Access Compliance Report

Public Rights-of-Way

(Curb Ramps)

Intersection ID: 44480	Main Street: LOYALIST_ST	Cross Street: REDDING_GLEN_AV	Location: SE
ADA ID: 82A4385E72B9	Ramp Type: Perp	Initial Pass/Fail: Fail	Overall Compliance: No
Severity Score: 8.75			
Codes/Mitigation Info/Possible Solution		Field Measurements/Component Compliance

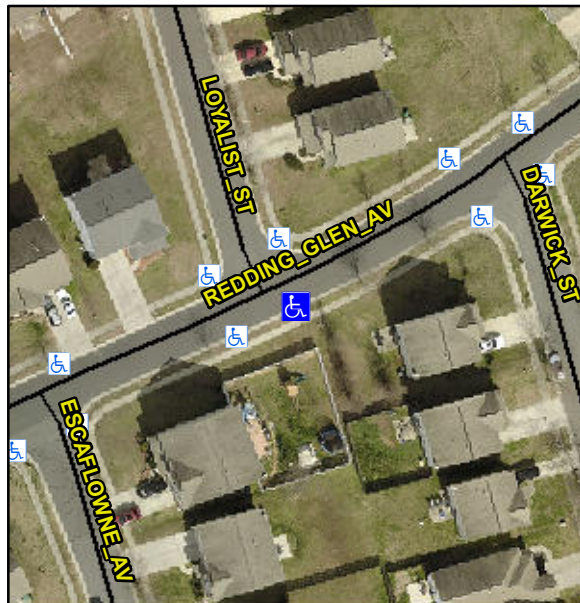
Not Found, R304.5.1

Compliance	Description	Data	Compliance	Description	Data
N/A	Ramp Length (in)	48.0	Yes	Ramp Slope (%)	6.5
No	Ramp Width (in)	47.0	Yes	Ramp XSlope (%)	0.9
N/A	Flare Type LT	N/A	N/A	Flare Type RT	N/A
N/A	Flare Slope LT (%)	N/A	N/A	Flare Slope RT (%)	N/A
N/A	Flare Traversable LT?	N/A	N/A	Flare Traversable RT?	N/A
N/A	Landing Length (in)	N/A	N/A	DWS Provided?	N/A
N/A	Landing Width (in)	N/A	N/A	DWS Contrast?	N/A
N/A	Landing Slope (%)	N/A	N/A	DWS Length (in)	N/A
N/A	Landing X Slope (%)	N/A	N/A	DWS Full Width?	N/A
N/A	Landing Curb? (Y/N)	N/A	N/A	DWS Offset (in)	N/A
N/A	Shared Landing?	N/A			
N/A	Gutter Ponding?	N/A	N/A	Gutter Slope (%)	N/A
N/A	Gutter Lip Ht (in)	N/A	N/A	Gutter X Slope (%)	N/A
N/A	Painted X Walk1?	No	N/A	Painted X Walk2?	N/A
	X Walk 1 Direction	To N		X Walk 2 Direction	N/A
N/A	X Walk 1 Width (in)	N/A	N/A	X Walk 2 Width (in)	N/A
	X Walk 1 Slope (%)	2.0		X Walk 2 Slope (%)	N/A
	X Walk 1 X Slope (%)	1.7		X Walk 2 X Slope (%)	N/A

Remove & Replace Entire Ramp.
